CERTIFICATE OF APPROPRIATENESS PLACARD

515 N BLOUNT STREET

LEWIS-SMITH HOUSE

PERMIT REVIEW COMMENTS / HISTORIC DISTRICT (TANIA TULLY 3/25/2014):

A201

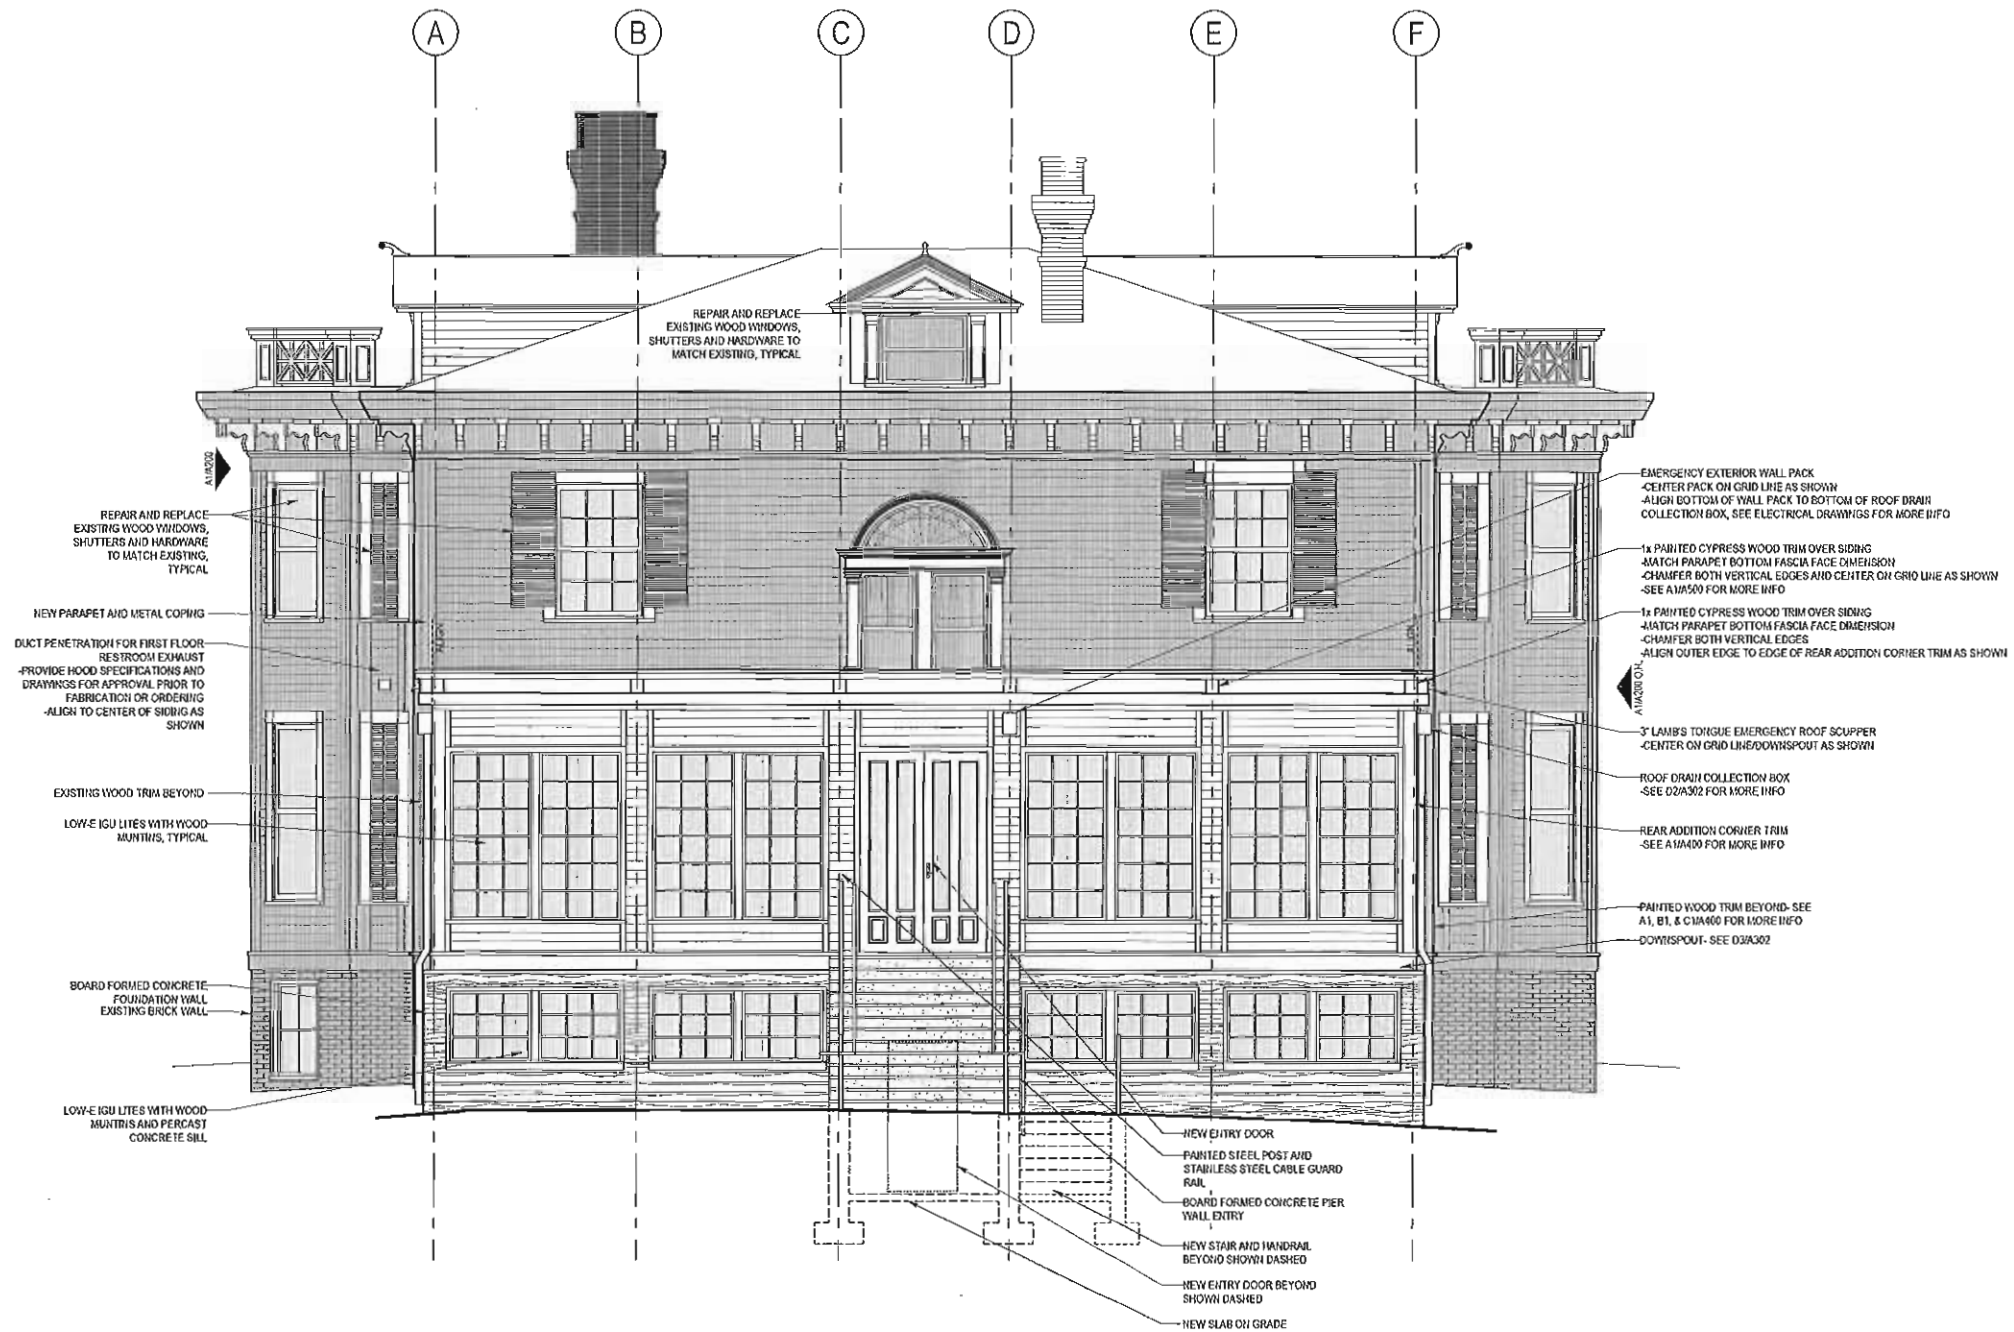
- NOT THIS COA
- Drawings still note that windows and shutters will be repaired or replaced. Replacement has not been approved. (conditions 1 & 2)
- RESPONSE : Notes utilizing the word "replace" do so in reference to missing windows and shutters or those components damaged beyond repair. A schedule of repair or replacement will be submitted for staff review prior to any demolition or repair work. Clarification has been added to elevations on sheets A200, A201, and A202.

Existing 2nd Floor railing.

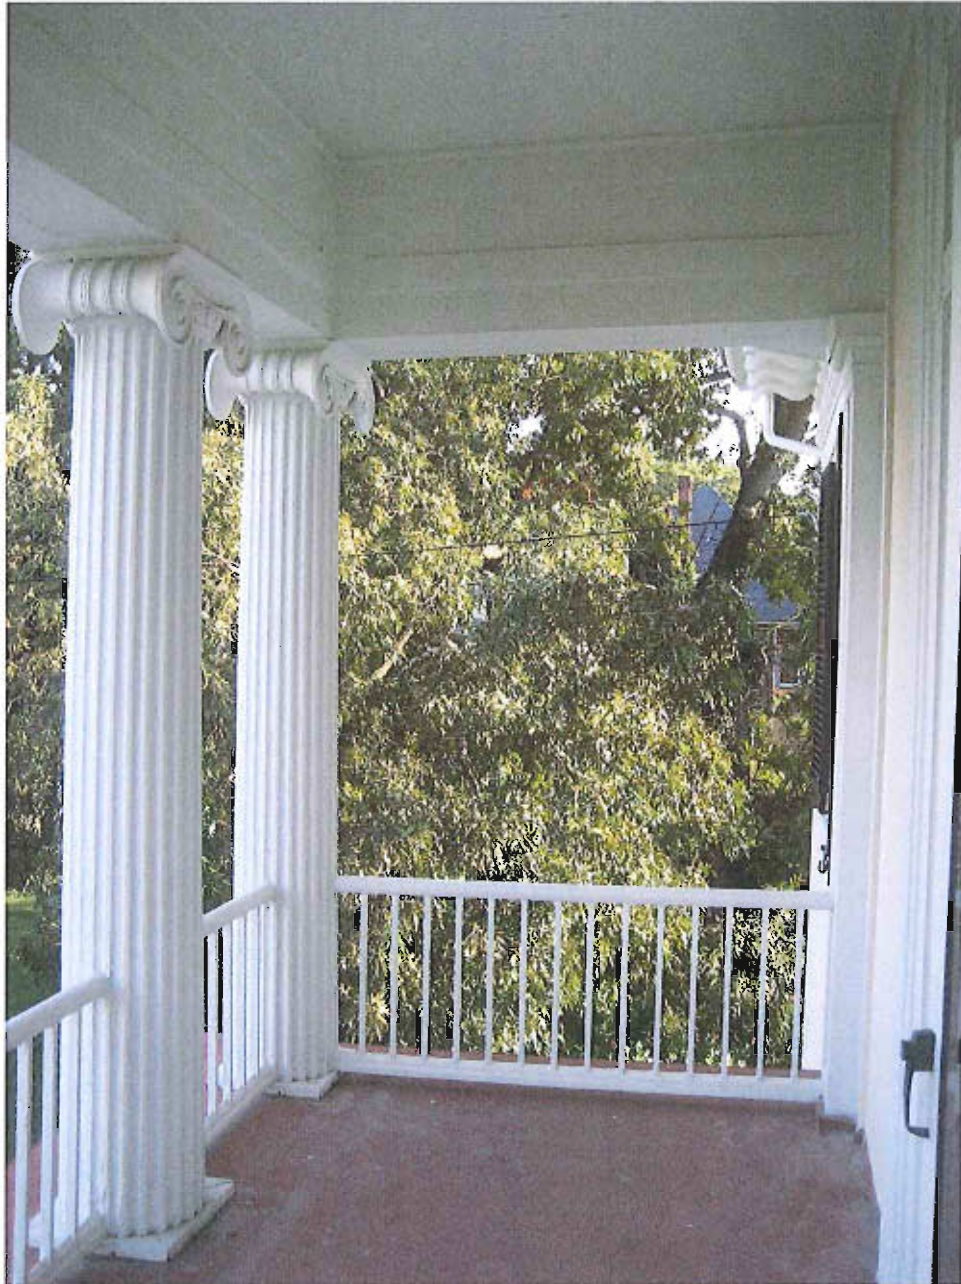
- 1) Please confirm that the new walkway from the handicap parking spot to the lift will have a water-washed finish.
- 2) Please send the floor plan that shows the vertical platform lift.
- 3) Do you have a detail of the new railing on the front porch?

- 1) yes, we will be water-wash the walkway for a more exposed aggregate finish.
- 2) I have attached sheet A100, which shows the walkway location
- 3) We do not have a detail of the front porch rail, just the narrative note describing our intent to match the existing railing materials, dimensions, and detailing at the second floor. We are finding in our practice, that when a detail is provided of historically significant features, the drawing is deferred to and field verifications are not made. We do expect shop drawings, as this rail will most likely be shop fabricated. I suspect it may be painted metal, but we won't know till we do some exploratory demolition. We will provide the shop drawings for staff review and comparison to the existing rail. I've attached an image of the rail at the second floor for your records.

Sheet No.
A100

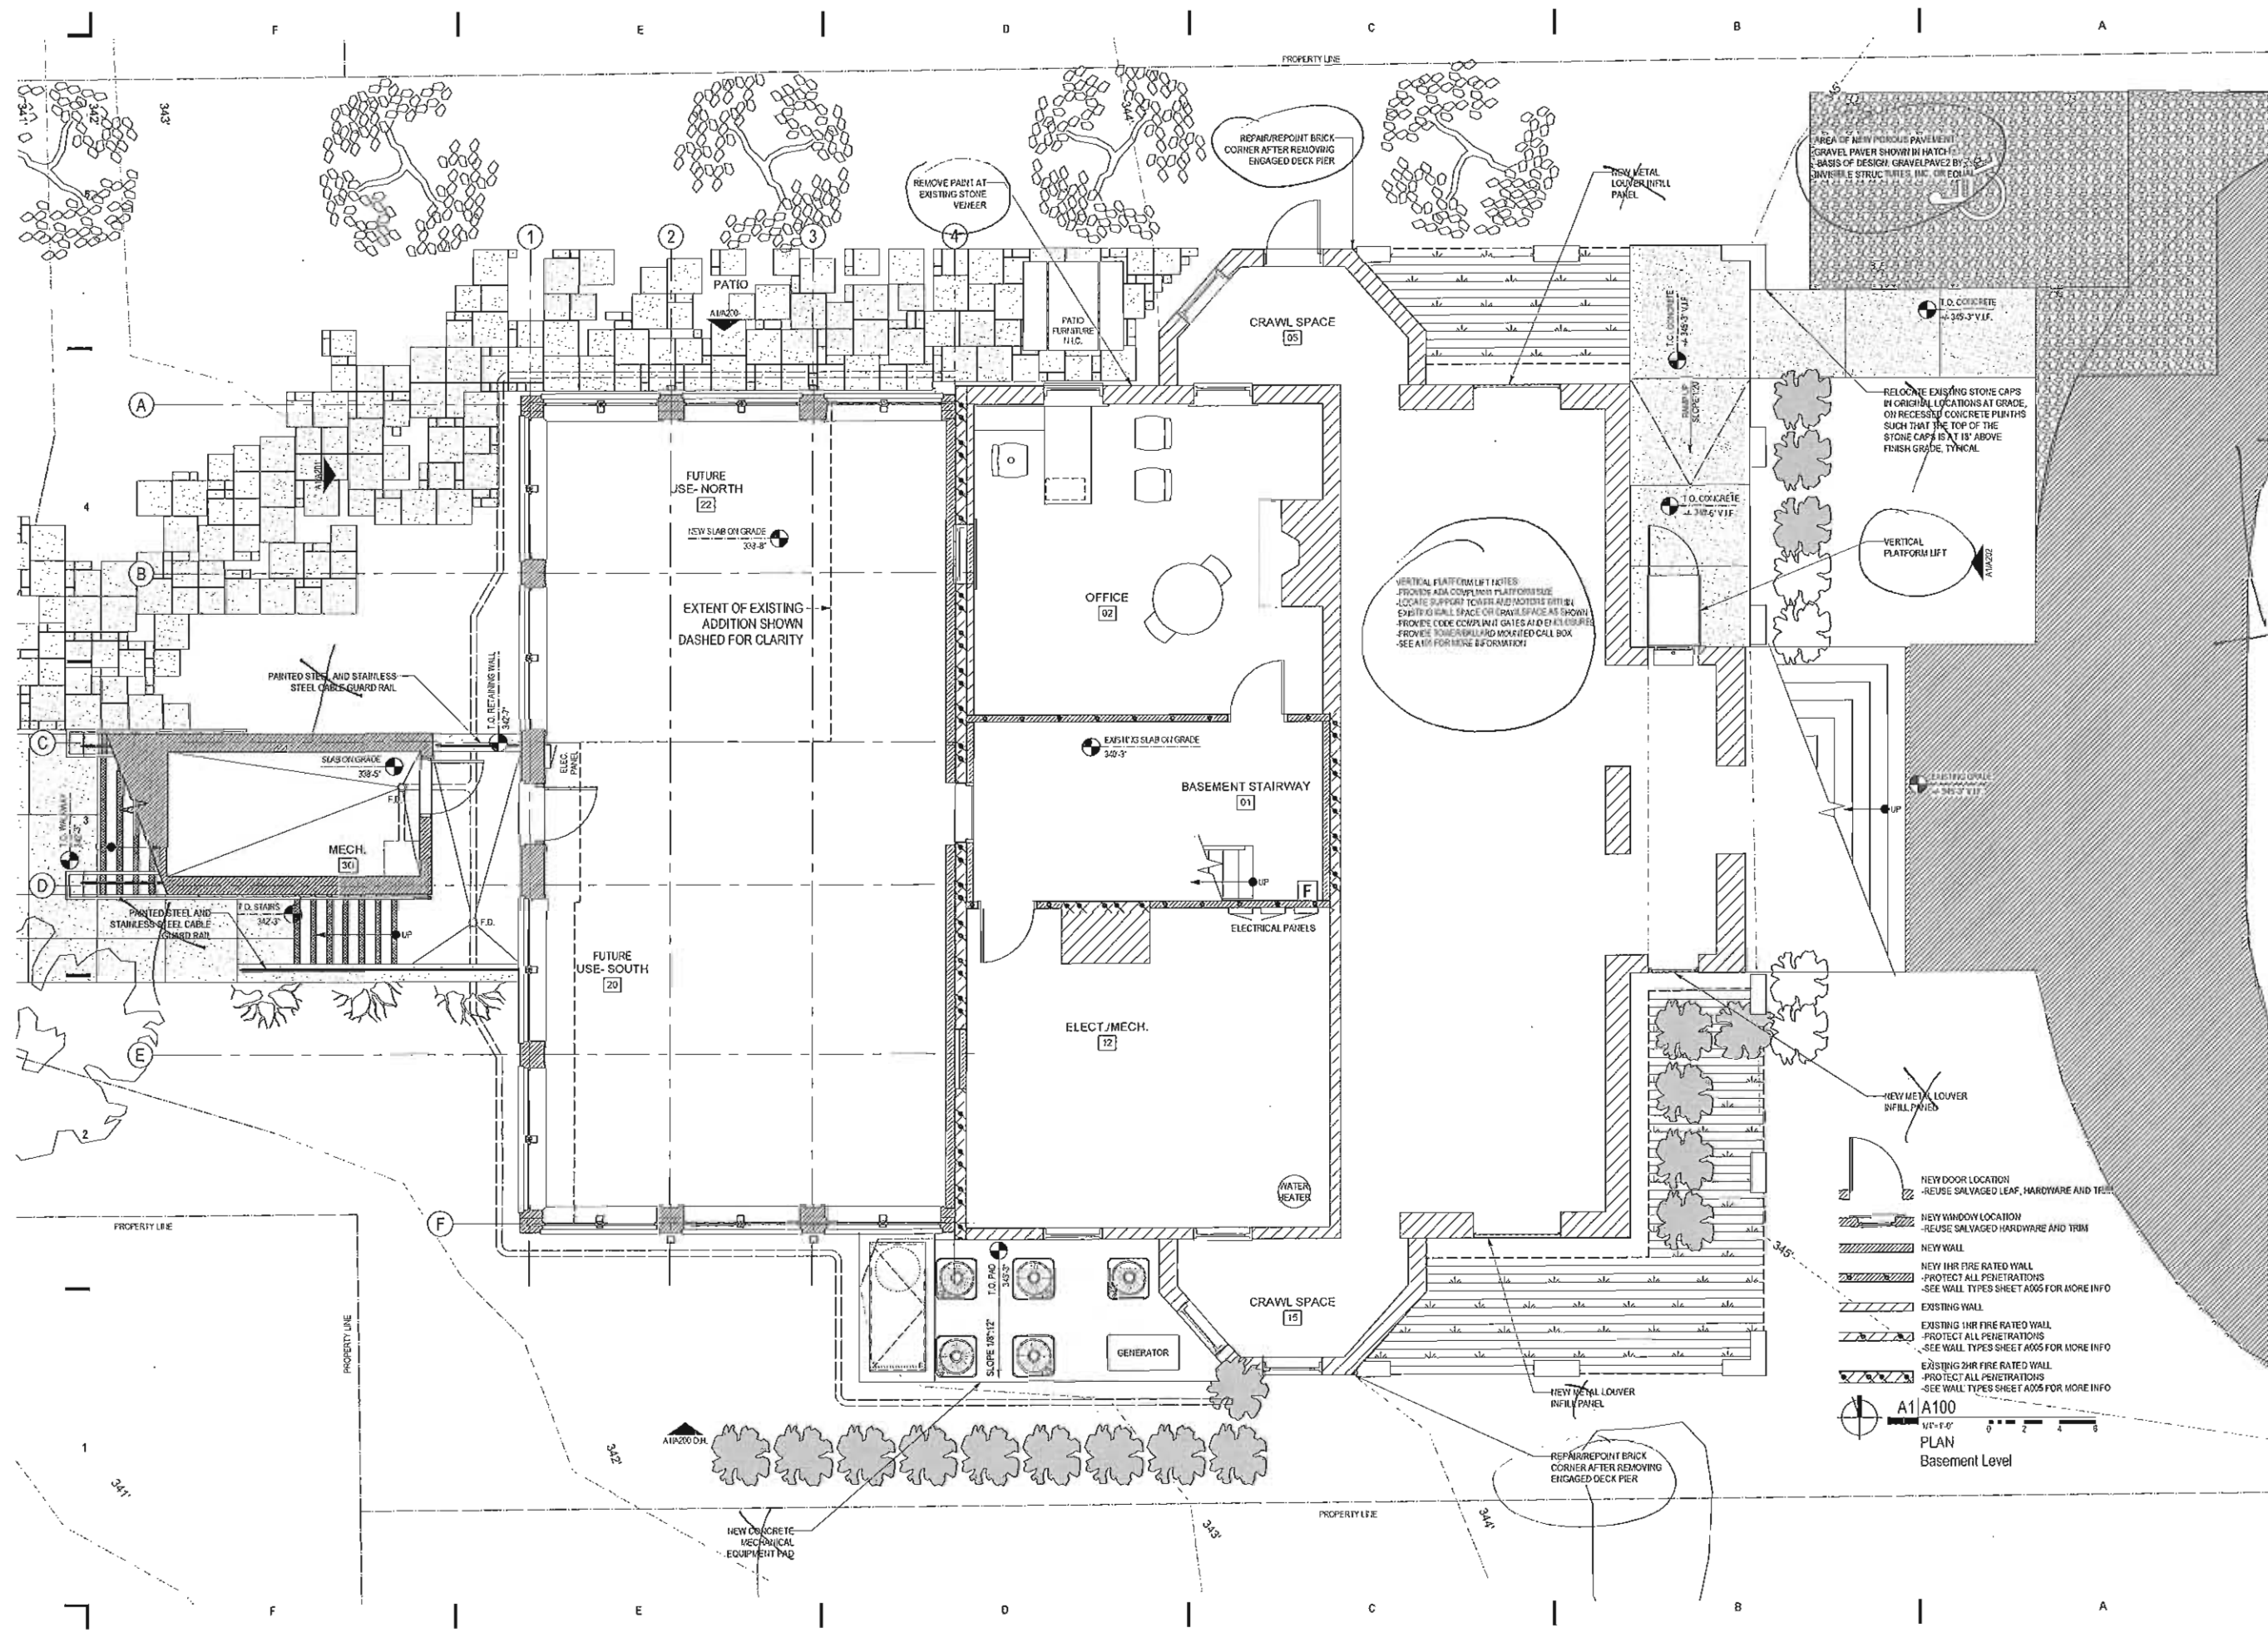
Only circled
items part of
this CoA.
